26 August 2021

#### Submission raising objection to Development Application DA2021/1229 Alterations and Additions to a Dwelling House 7 Pavilion Street, Queenscliff

Figure 1: Extract from submitted DA plans showing proposed privacy screen

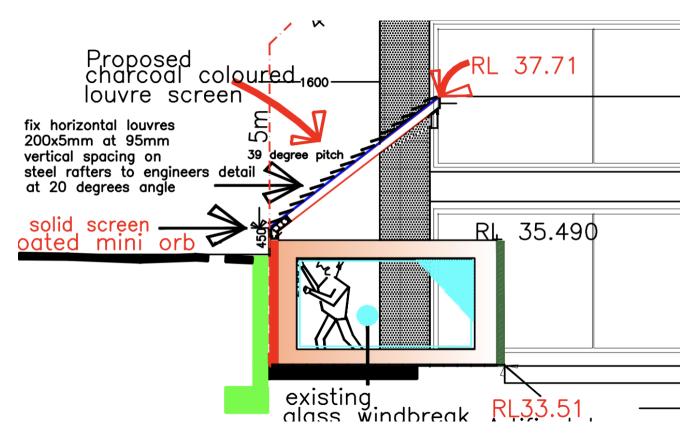
It is my interpretation of the submitted plans and information provided that the proposed privacy screen is not a simple vertical structure with minimal built form. The proposed screen will project initially to a height of 2.15 metres from ground level as it abuts the existing southern boundary and then extend a further 2.06 metres at an angle of 39 degrees to reach an overall height of 4.2 metres.

By virtue of the overall height and projecting roof form, the impact of the proposed development would be far greater than a simple vertical screen.

**Comment:** The DCP map side boundary setback requirements for the subject site are 0.9 metres. The proposed development abuts the southern side boundary and has no side setback. By virtue of the height and design of the proposed, the privacy screen and projecting louvres would be visually intrusive when viewed from the streetscene and detrimentally impact on the
